RENESAS TECHNICAL UPDATE

Product Category	MPU/MCU		Document No.	TN-SH7-A867B/E	Rev.	2.00
Title	Note on Procedures for Programming and Erasing the Flash Memory		Information Category	Technical Notification		
Applicable Product	See below.	Lot No.	Reference Document	See below.		
		All lots

Figure 21.11 Programming Procedure

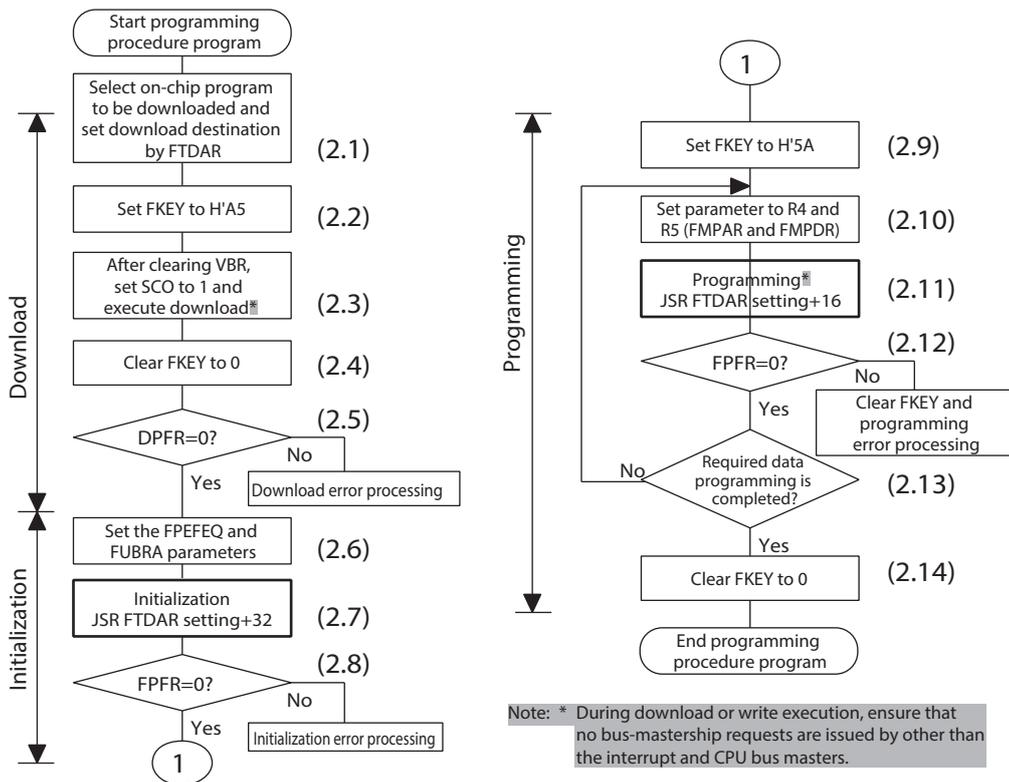
[Addition (p.926)]

Processing for a bus master other than the CPU to acquire bus mastership (such as for DMA transfer, DTC transfer, or refreshing the SDRAM) must not proceed during downloading, programming, and erasure.

Figure 21.12 Erasing Procedure

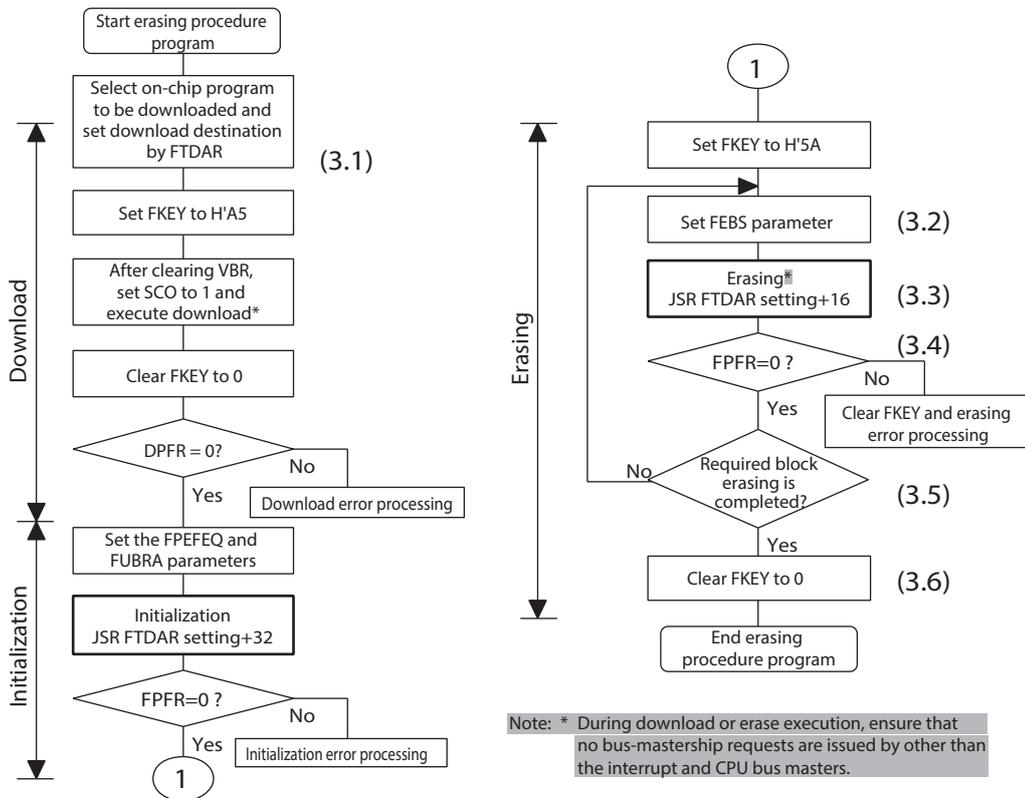
[Addition (p.932)]

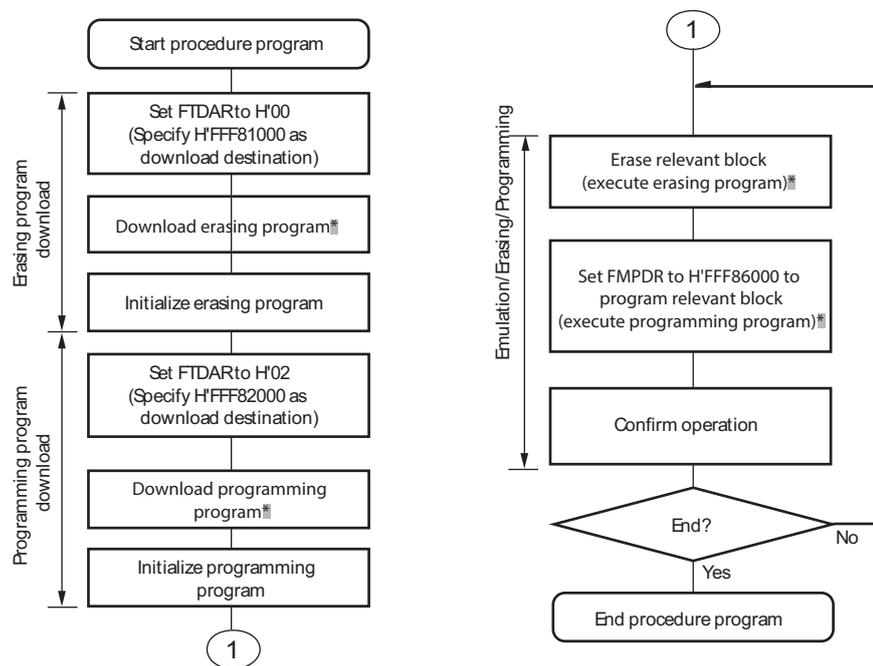
(3.3) Erasure

Similar to as in programming, there is an entry point of the erasing program in the area from (download start address set by FTDAR) + 16 bytes of on-chip RAM. The subroutine is called and erasing is executed by using the following steps.

1. The general registers other than R0 are saved in the erasing program.
2. R0 is a return value of the FPFR parameter.
3. Since the stack area is used in the erasing program, a stack area of maximum 128 bytes must be reserved in RAM.
4. During erase processing, ensure that no bus-mastership requests are issued by other than the interrupt and CPU bus masters. For details, see section 21.7.2, Interrupts during Programming/Erasing.

Figure 21.14 Procedure for Programming User MAT in User Boot Mode

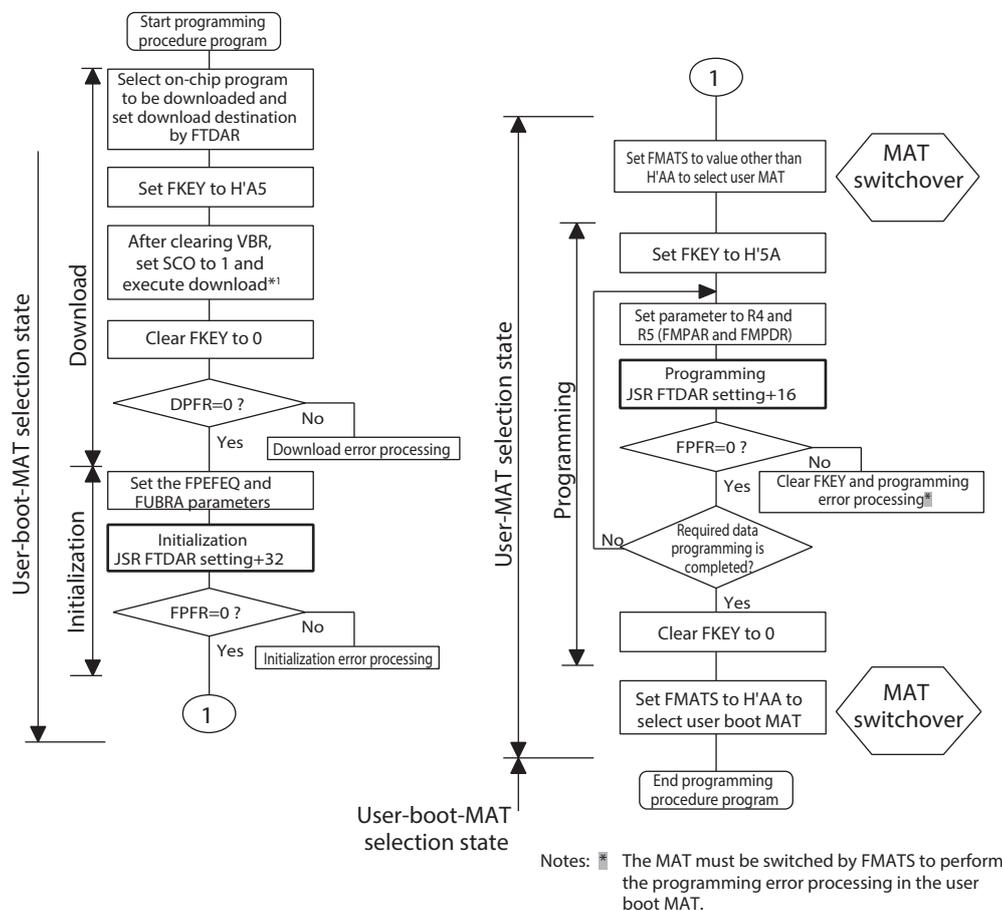
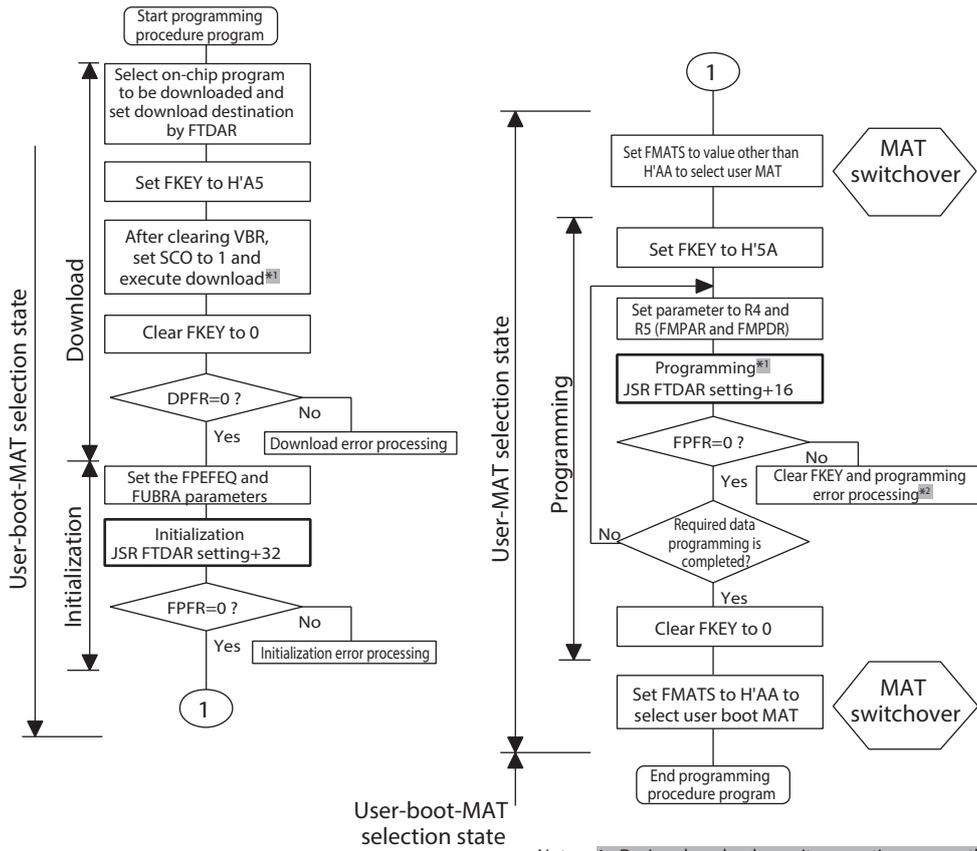
[Before correction (p.936)]

- Notes:
1. During download or write execution, ensure that no bus-mastership requests are issued by other than the interrupt and CPU bus masters.
 2. The MAT must be switched by FMATS to perform the programming error processing in the user boot MAT.

Figure 21.15 Procedure for Erasing User MAT in User Boot Mode

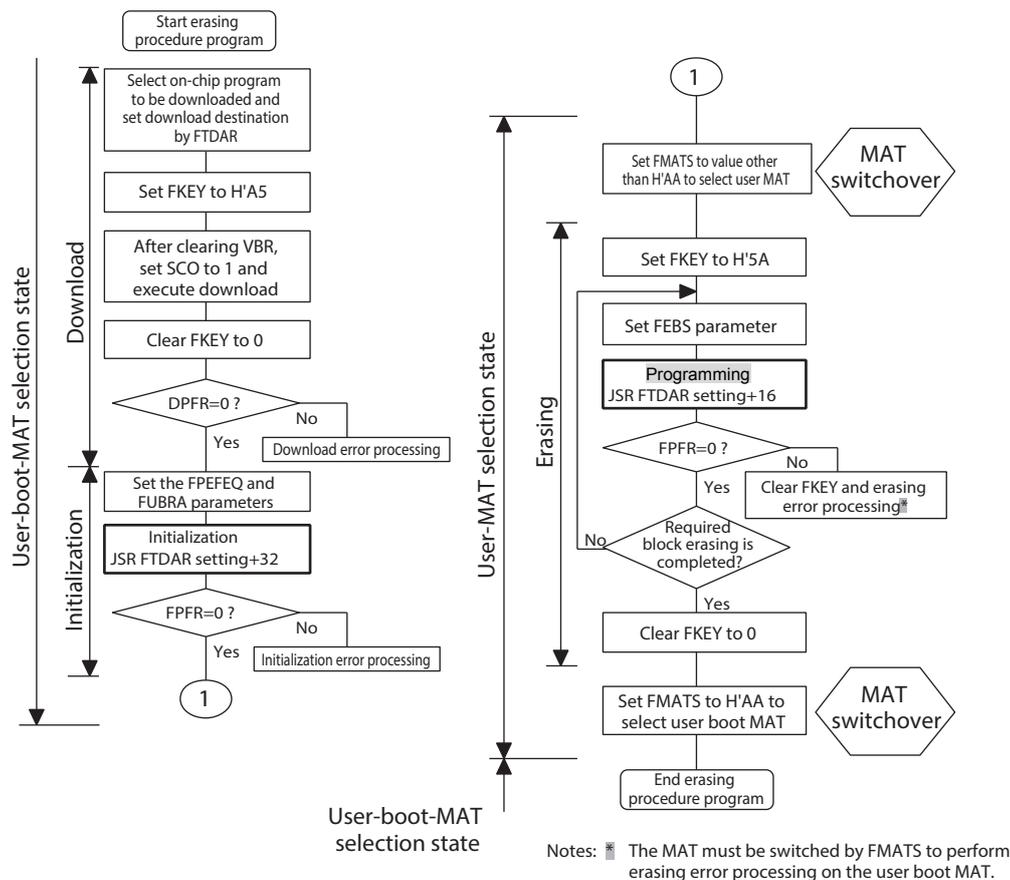
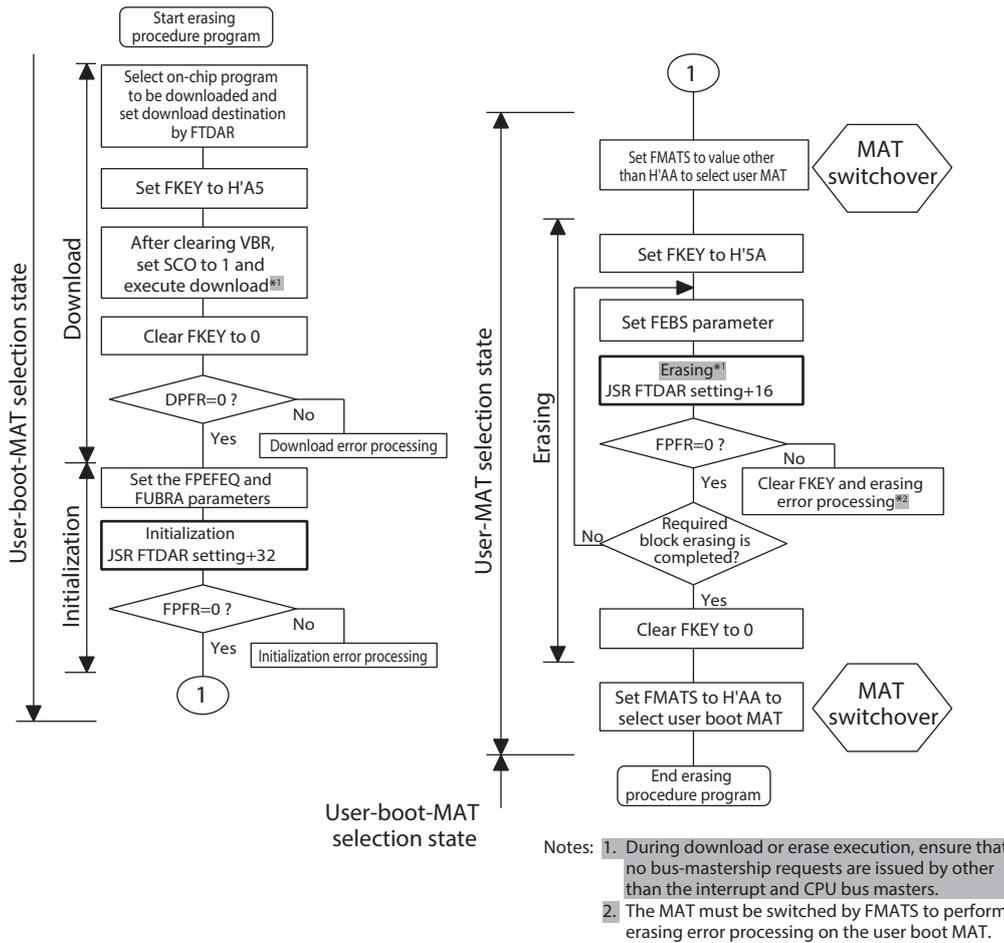
[Before Correction (p.938)]

[After correction]
